Accessibility Survey

City of Downey Brock Avenue - Conrad Street To Cul-de-sac

Date of Inspection
1/29/2017

Prepared By
Disability Access Consultants
(800) 743-7067

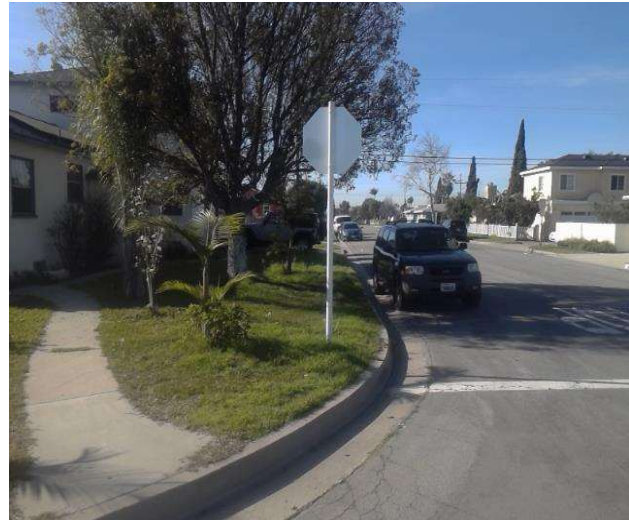
Section of sidewalk is missing and consists of dirt, grass or gravel.

On-Site Finding 66.00 feet

Provide a compliant sidewalk for the missing section.

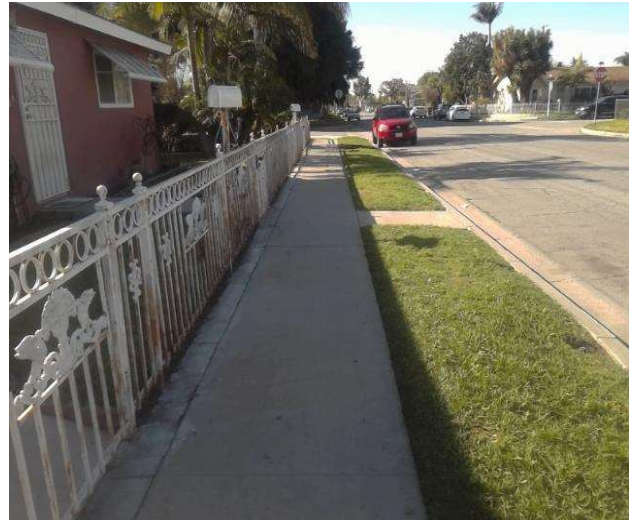
Sidewalk does not have enough width.

On-Site Finding 47.50 inches for 107.00 feet

Widen the sidewalk to the recommended value.

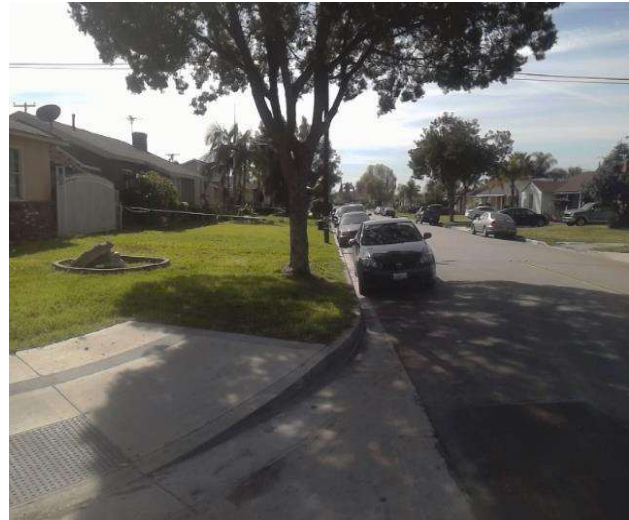
There is no 60X60 turn area at every 200 feet.

On-Site Finding Not Found

Provide a 60X60 turn every 200 feet on the sidewalk.

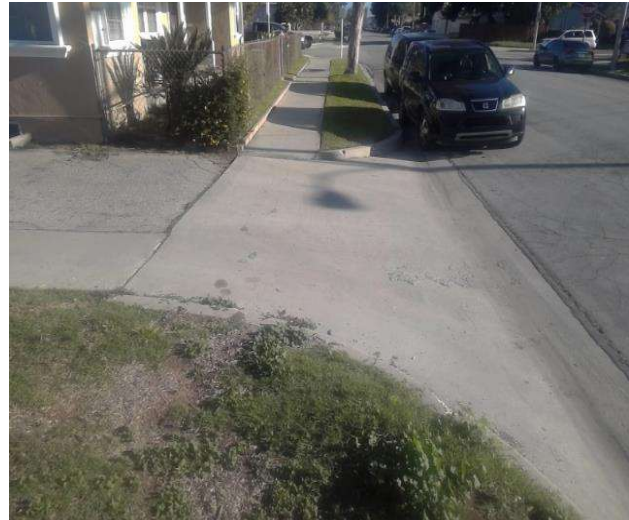
There is a curb on the designated path of travel.

On-Site Finding Not Compliant

Provide a compliant curb ramp.

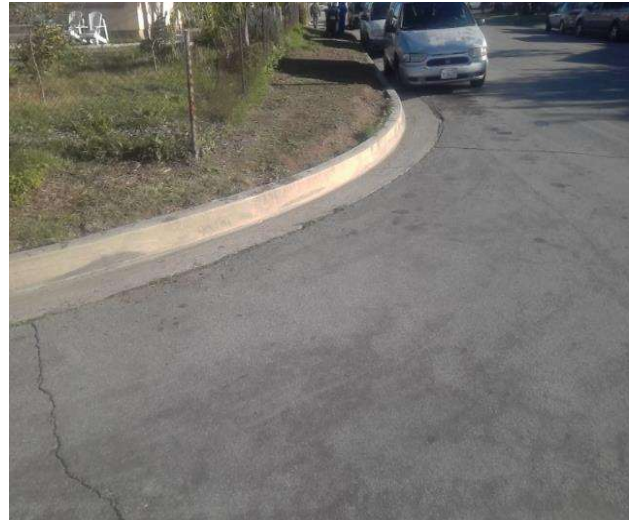
There is a curb on the designated path of travel.

On-Site Finding Not Compliant

Provide a compliant curb ramp.

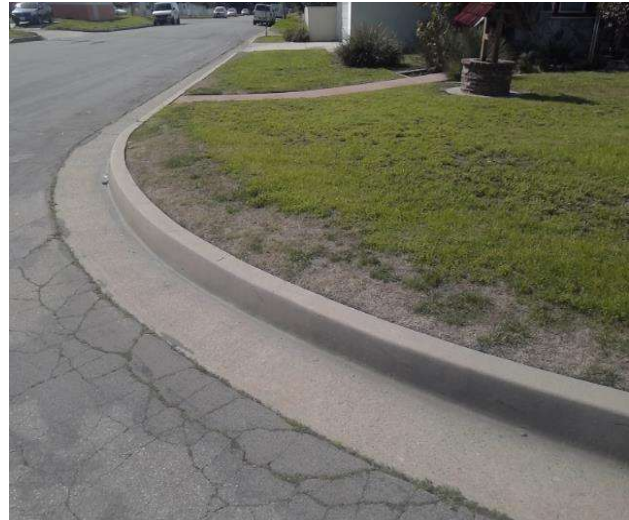
There is a curb on the designated path of travel.

On-Site Finding Not Compliant

Provide a compliant curb ramp.
